UNITED STATES PATENT AND TRADEMARK OFFICE

APPLICATION NO.	FILING DATE	FIRST NAMED INVENTOR	ATTORNEY DOCKET NO.	CONFIRMATION NO.
09/834,208	04/13/2001	G. Thomas Wolf		3950
42082	7590	08/25/2005		
CONWELL LLC 130 LUBRANO DRIVE, SUITE 112 ANNAPOLIS, MD 21401			EXAMINER MENDOZA, MICHAEL G	
			ART UNIT 3731	PAPER NUMBER

Office Action Summary

DETAILED ACTION

Figure 1

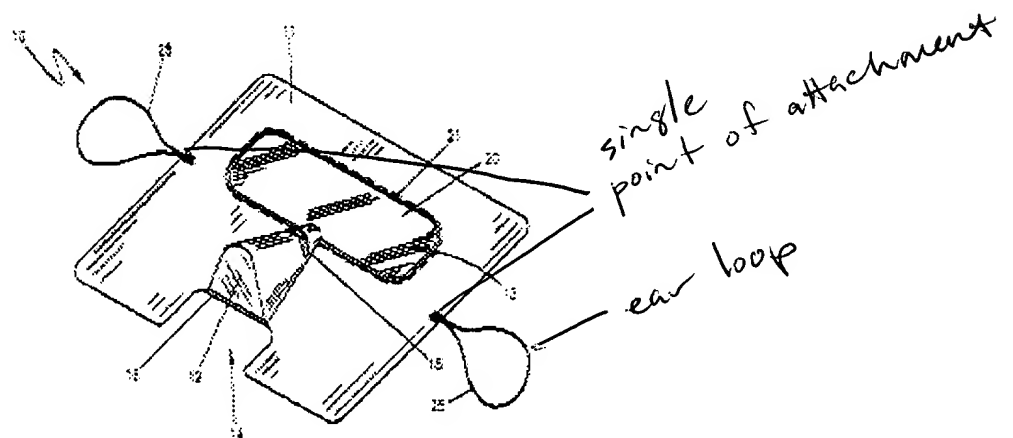
4. The Applicant argues that the Examiner's concerns have not been articulated. The rejections stated that duplication of parts required only routine skill in the art. The Hudson reference teaches one point of attachment on each side of the mask. Duplication of another point of attachment would require only routine skill in the art. The ear loop of Hudson using one point of attachment as in the rejection of claim 5 would look similar to Patent 6079980.

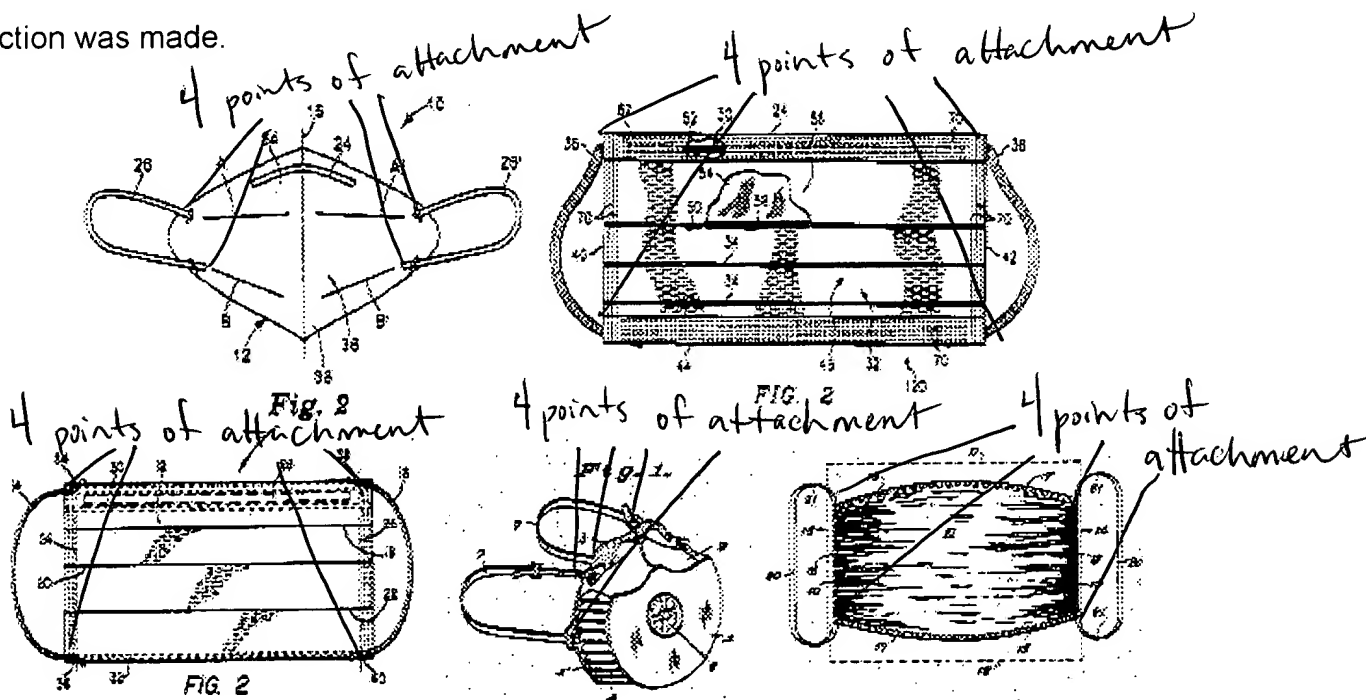
5. As stated in the rejections 6 and 9, it is well known in the art of mask to secure a mask using four points of attachment when using ear loops as evidenced by Patent 2494406, 2798483, 4802473, 4941470, 5701892, 5813398, and 6394090. Duplication of the points of attachment would look similar to the above stated references and is well

known in the art to use the four points of attachment as opposed to the single attachment as shown above in Patent 6079980.
